Submission on Materials Recovery Facility – Fyshwick - EIS application 201700053

This is a submission on the draft Environmental Impact Statement (EIS) lodged by Capital Recycling Solutions Pty Ltd regarding its proposed Materials Recovery Facility (MRF).

Summer 2009

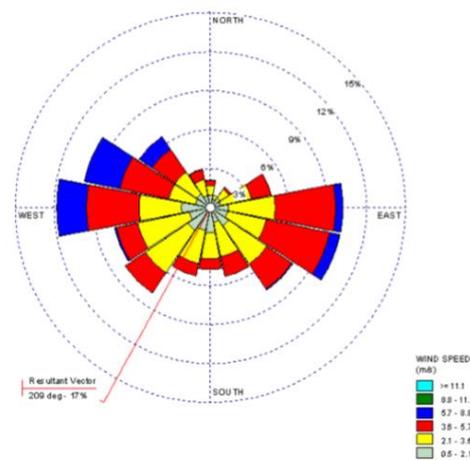
The proposed location of the MRF is just 849 metres East/Southeast of the Fyshwick Fresh Food Markets. During Summer the prevailing winds are precisely from the East/Southeast. During Autumn, significant components of the wind are from the East/Southeast. Please see the wind roses below. Garbage stinks most is hot weather during Summer. Putting a garbage facility directly upwind of, and only 849 metres away from, one of Canberra's two fresh food markets does not accord with proper planning principles.
